Bridge No. 8
Dundas St. Over Etobicoke Creek
W.P. 277-66, Site No. 24-187
Dundas St. & Hwy. 27 Interchange
District No. 6

Hwy. #27 and Dundas St. Interchange
and C.P.R. Overhead North of Q.E.W.
and Hwy. #27 Interchange.
W.J. 65-P-104 and W.J. 66-P-103,
District No. 6 (Toronto).

FOUNDATION INVESTIGATION REPORT
For
The Proposed Dundas St. and Hwy. #27
Interchange and Bloor St. Underpass,
Hwy. #27 -- District #6 (Toronto)
M.J. 66-P-103 -- W.P. 275-64-2

BRIDGE No. 8

FOUNDATION LAYOUT
SCALE 1" = 10'-0"

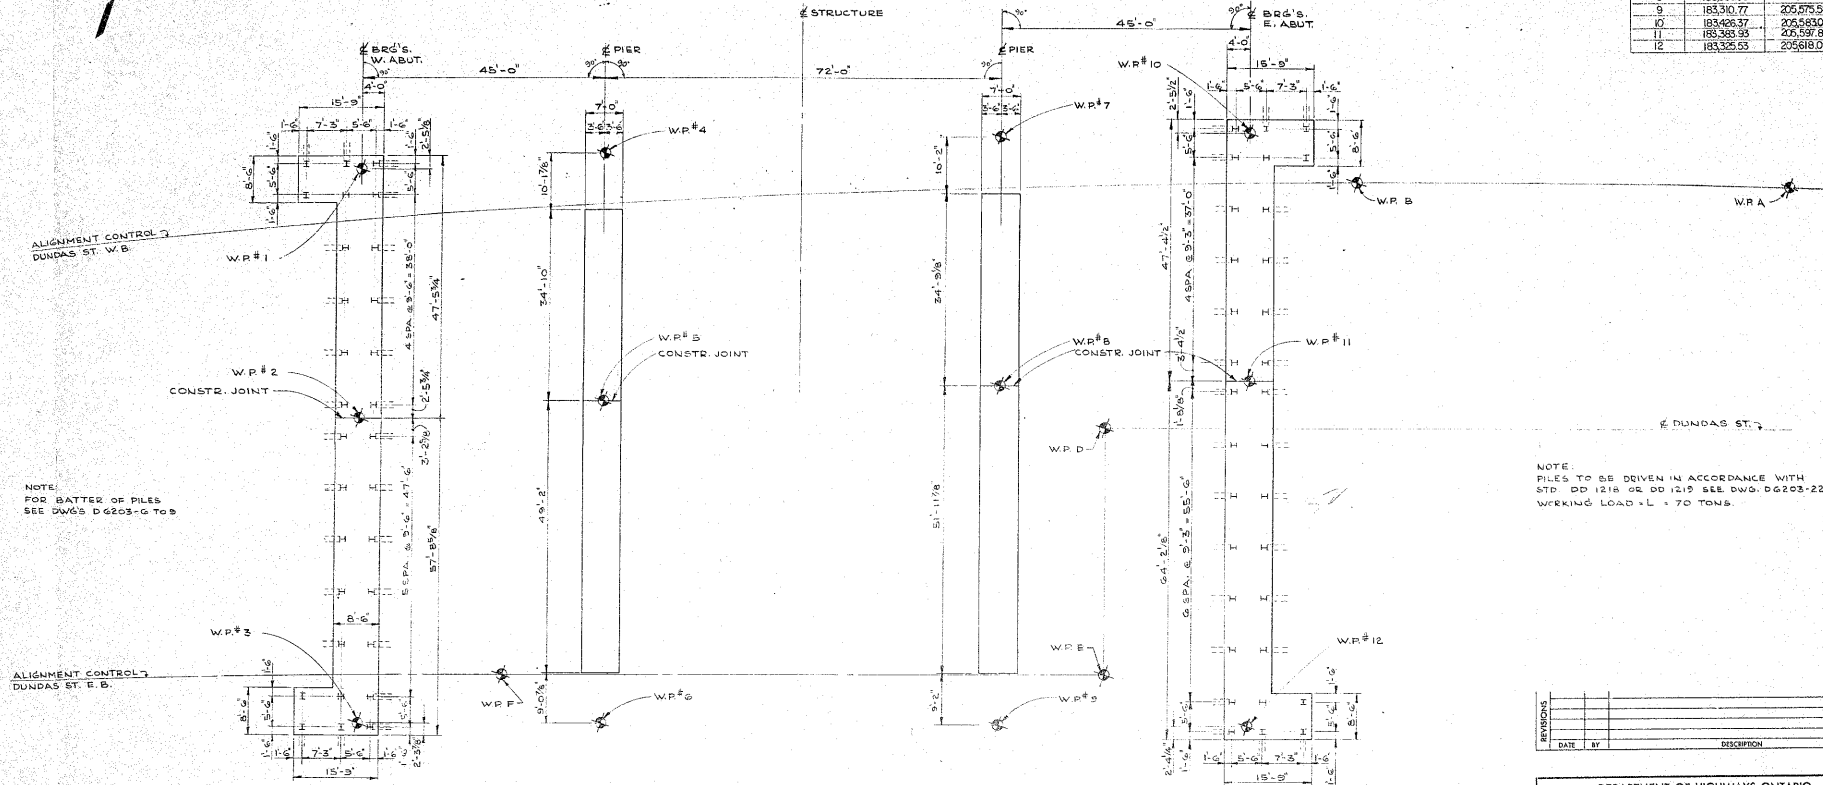
Pile lengths are not marked on the design drawings.
We recommend pile lengths to be provided as follows:

Location	No.	Type	Pile Lengths
East Abutment	32	12 BP @ 53	22 Ft.
West Abutment	30		20 Ft.

Above lengths are valid provided that scour does not affect the soil beneath El. 355 ft.

The given lengths include a one-ft. allowance for buckling during driving.
